# LCNF Competition

## SEPD LEAN - Interrogation Report

**Document No. :** FNC 45646-79862V

**Client :** Ofgem

**Fig.1 SEP D Transformer Efficiency against EU Requirements**

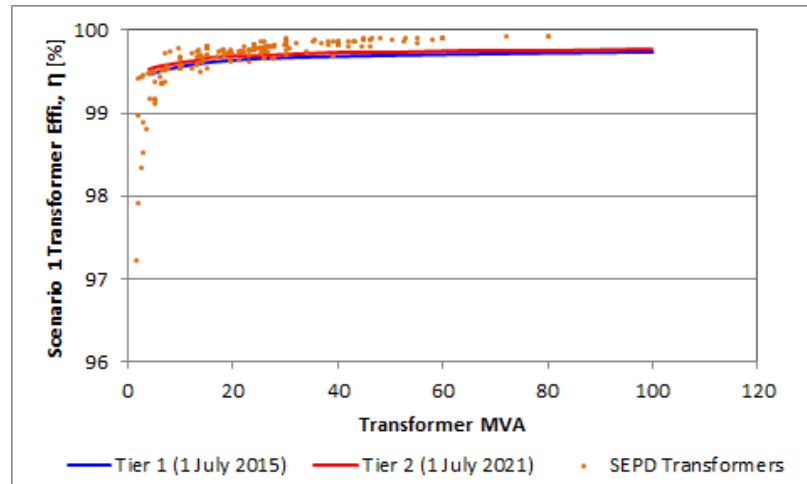
**Challenge 1:** There is limited substantiation in the submission for the claim of 90MWh/annum savings in TASS enabled substation. Section 3.4 articulates the process that has been followed to estimate the applicability of the methods but detailed results have not been included.

Given that the rest of the claims about the applicability of the methods are predicated on the 90MWh claim, the source and validity of the supporting assumptions should be demonstrated and evidenced more rigorously in the submission.

The figure of 90MWh per annum is indicative of the fixed losses incurred at a typical primary substation transformer. This is based on a transformer having an iron loss of around 10-12kW and then multiplied by 8760 hours to give the annual volume of losses incurred i.e. 96MWh.

The figure of 90MWh per year is an example of the typical losses in high-loss transformers that could be saved if the TASS method is adopted. In developing the business case desktop analysis, half-hourly demand profile data from a previous IFI Isle of Wight study was used in conjunction with the iron losses recorded at commissioning. We repeated this exercise across SEPD's asset portfolio using figures from SEPD's Long-term Development Statement to "flex" the Isle of Wight demand profile, reflecting the

<p><b>METHOD 2:</b> For Method 2 (ANT) deployment we have assumed that existing feeder automation schemes can be relatively easily adapted through the introduction of additional ENMAC (DNO SCADA/DMS system) scripting. Where deployed, ENMAC scripting can usually be extended to additional feeders using in-house resources, often at zero direct cost e.g. control engineers during periods of low activity.</p> <p>In this way, the deployment of ANT throughout GB is not expected to present any issue to DNOs that use the ENMAC SCADA/DMS (the only DNO not to use these systems is ENW although they have an ENMAC system deployed on its Tier 2 projects).</p> <p><b>Conclusion 1:</b> Response is adequate. No further comment.</p>
<p><b>Sub-criterion (a.iii) – The financial benefit of each method compared to most efficient existing method</b></p>	<p><b>Challenge 1:</b> The ‘Base Case’ used by Appendix 5 to the submission assumes simply a ‘do nothing’ alternative approach –i.e. the LEAN methods are not implemented and no transformer improvements are undertaken. In the submission body text however the LEAN methods are contrasted with a rolling programme of transformer replacements. Appendix 8 also contains significant research on other loss mitigation approaches. However, within the submission little benefit is taken from this research in establishing an alternative ‘best practice’ base case.</p> <p>Evidence is required to verify that appropriate technical &amp; financial analysis has been undertaken to establish a baseline for network reinforcement in comparison to LEAN method deployment?</p> <p><b>Answer 1:</b></p> <p>The rolling programme of transformer replacements will result in the replacement of all existing transformers in approximately 60-80 years. LEAN provides us with a method capable of delivering targeted loss savings at sites with periods of low peak demands in a much shorter timeframe.</p> <p>In addition, the EU Directive 2009/125/EC only applies to transformers purchased from 2015. The Directive specifies incremental transformer efficiency specification in two separate phases: Tier 1 to commence from 1st Jul 2015, and Tier 2 from 1st Jul 2021.</p> <p>Fig.1 below shows transformer MVAs versus peak efficiencies for all of SEPD’s existing 33/11 kV primary distribution transformers plotted against the EU Directive Tier 1 (blue curve) and Tier 2 (red curve) requirements. Among these primary distribution transformers, only about 17% fall below EU Directive’s Tier 1 transformer efficiency specification, and about 25% below Tier 2 specification. In summary, the majority of SEPD’s transformers</p>

already comply with (or are more efficient than) the EU Directive's Tier 1 and 2 specifications.

Therefore, from SEP D's existing asset perspective, the impact of this EU Directive on the presented LEAN business case is not expected to have a significant impact on the base case scenario and we have not calculated this within the business case.
